Sub: Corrigendum-01: Amendment to Tender specification document & due date extension

- 1. E-Tender specification No: 2101094
- 2. **Scope of work:** Detailed drawing preparation based on Input design drawings provided by BHEL-Engineering Centers for Flue Gas Desulphurization (FGD) Package as specified in scope and getting approval from BHEL- Engineering Centers/ NTPC. Fabrication and supply of finished product (procurement of raw structural steel will be in the scope of bidder) i.e. structures of FGD as per BOM/Drawings at 2X500 MW NTPC Mauda, Stage-I, TPP-FGD, Maharashtra.

2 X 500 MW MAUDA STPP-FGD PACKAGE			
DWG / DOC NO AND TITLE : 9561-109-ISG-PVC-B-445 - CONVEYOR LBC-1AB-GA OF GALLERY & TRESTLES R0				
SL NO	NTPC COMMENTS	BHEL REPLY		
1	Hold	Staad file has been revised and errors resolved		
2	PTFE bearing shall be provided for slinding support	Accepted. PTFE indicated in elevation view.		
3	COMPLY TO COMMENTS MARKED DESIGN DOCUMENT	Complied		
4	DESIGN/DRAWING TO CONFORM TO LATEST MECHANICAL/ELECTRICAL GADRG.	Accepted. Trestle Tr-2A introduced for structural requirement, after discussion with mechanical. The same will be updated in Mech GA dwg.		
5	ALL FURTHER CHANGES TO BE I

FOR 9561-109-PEM-PVC-B-102- R1 NTPC COMMENTS RECEIVED VIDE LETTER Reference: CC:PE: 9561:109:39703 DATED 09.12.2019

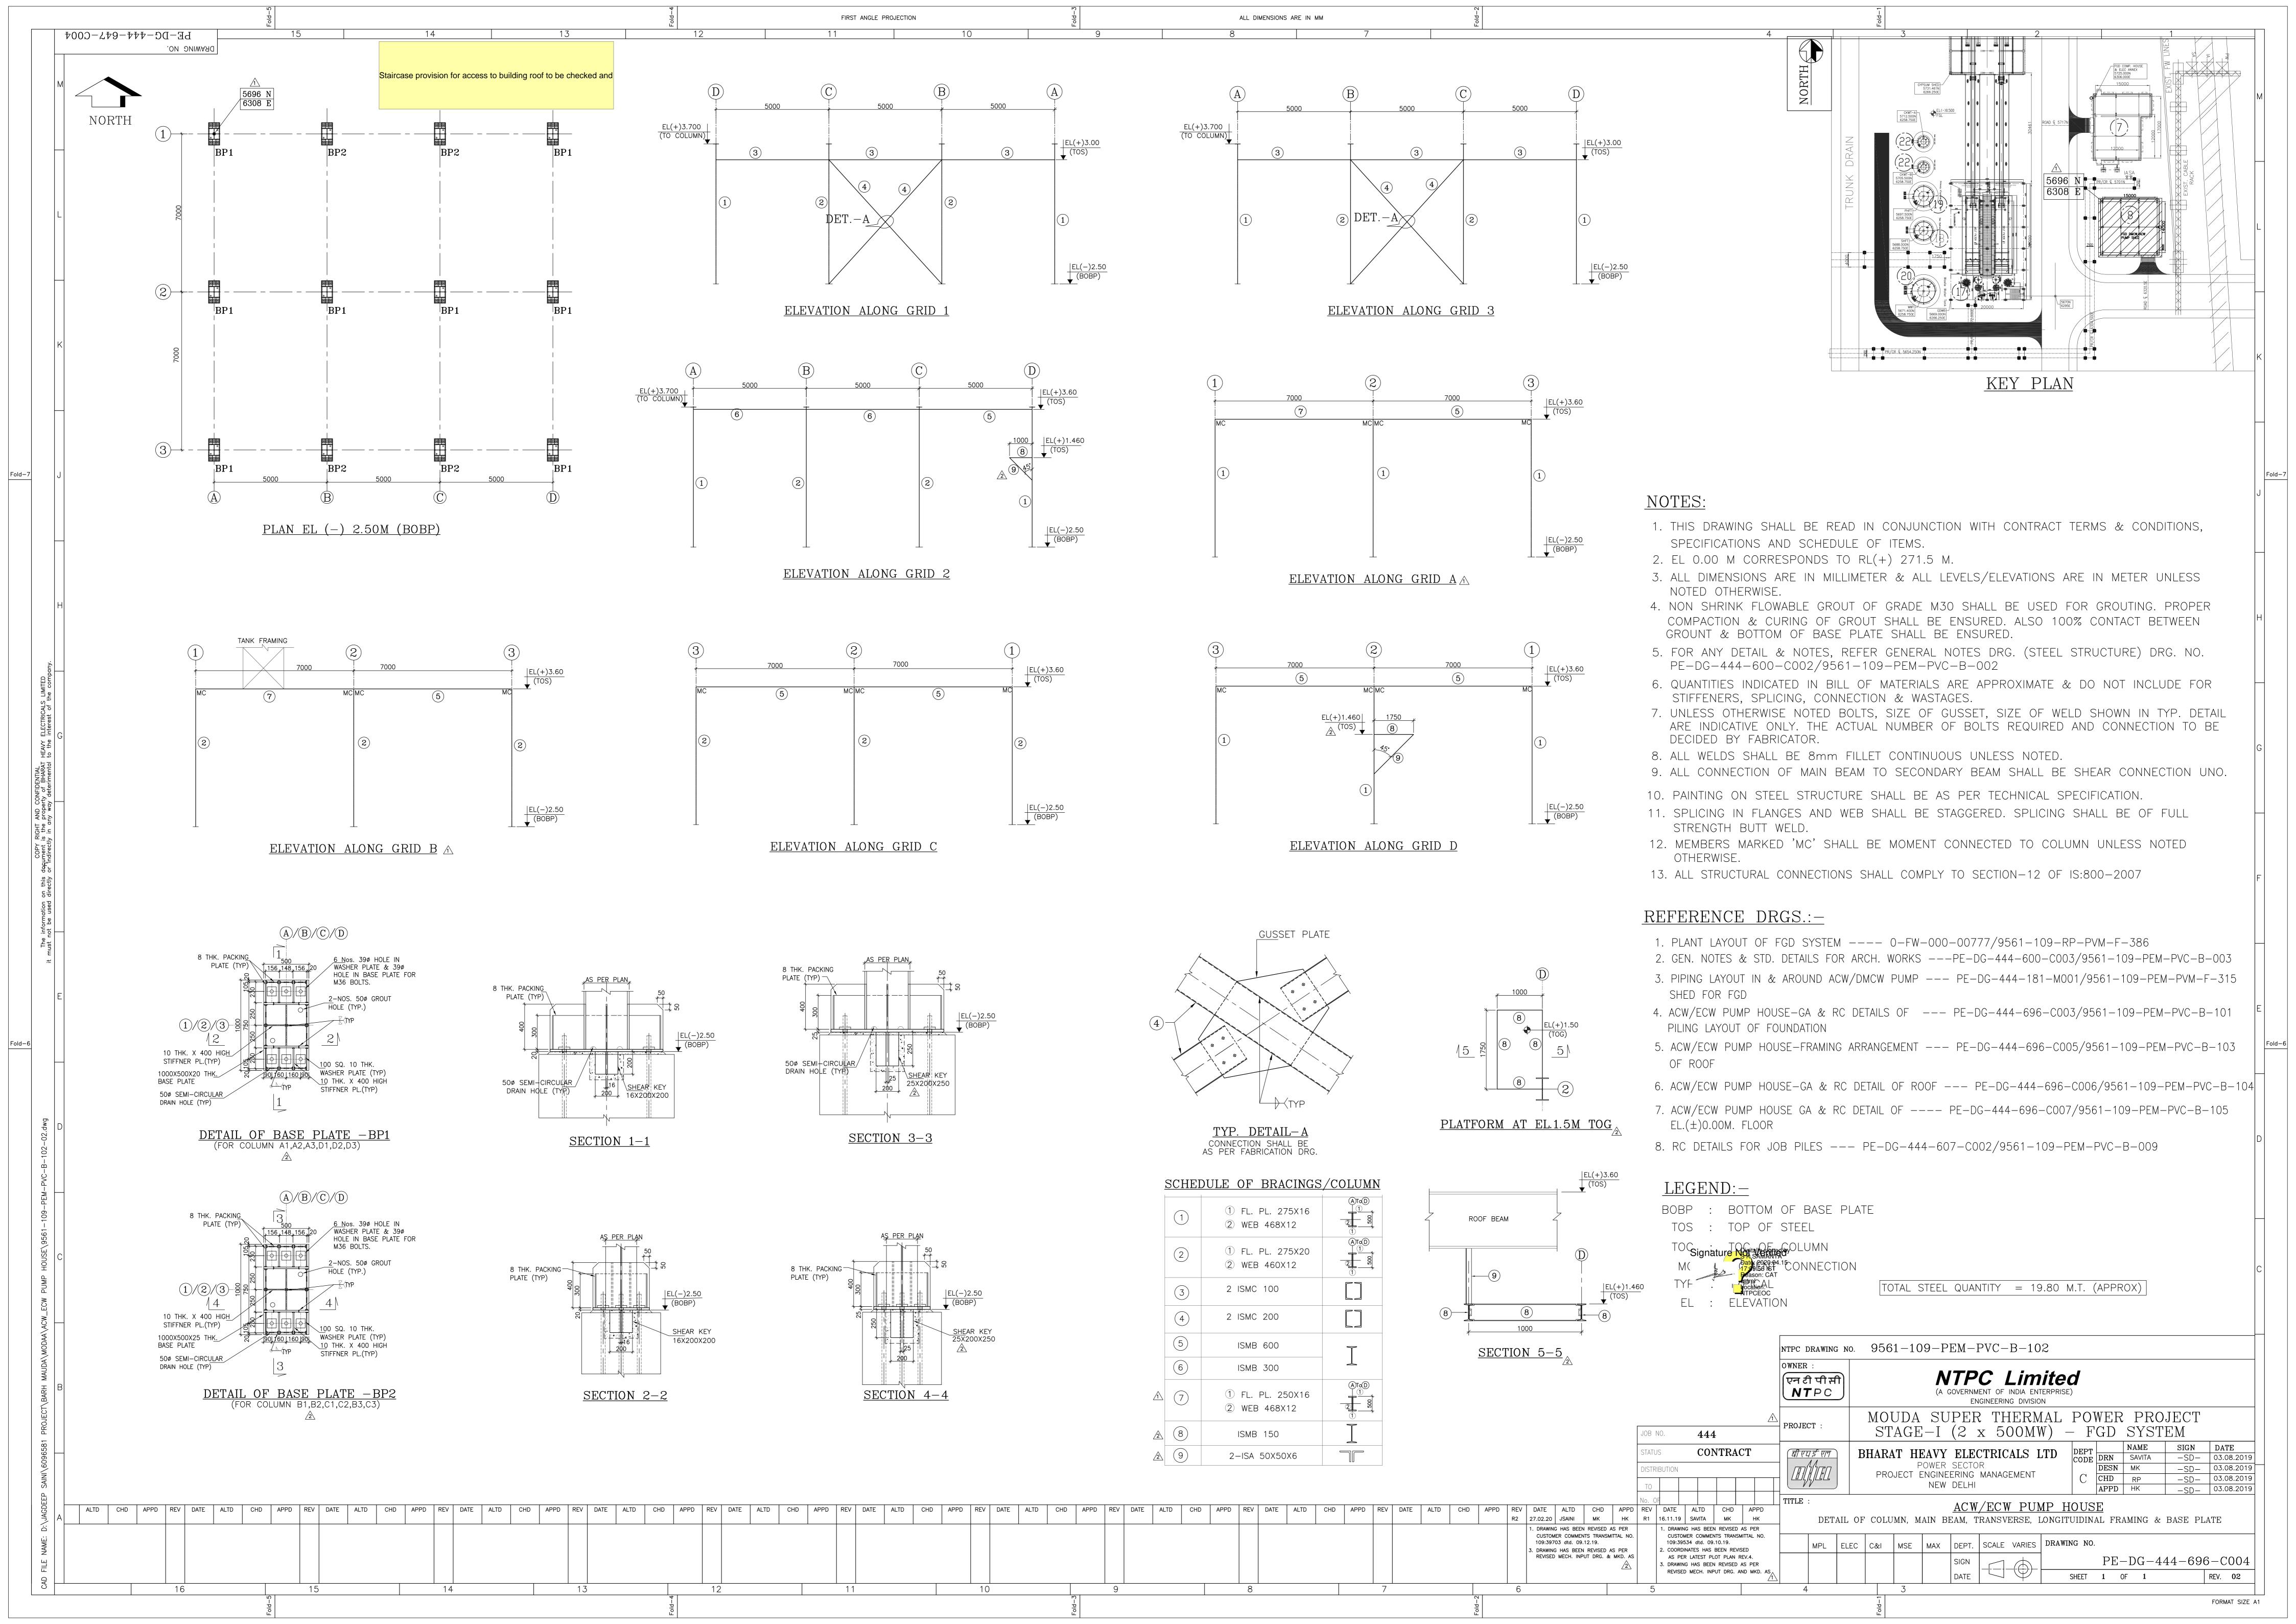
SL NO	NTPC COMMENT	BHEL REPLY
1	Monorail beam to be shown in both plan and elevation and fixing detail of same also to be shown.	
2	Structure for hoist maintenance platform and access provision to the platform also to be shown.	Incorporated.
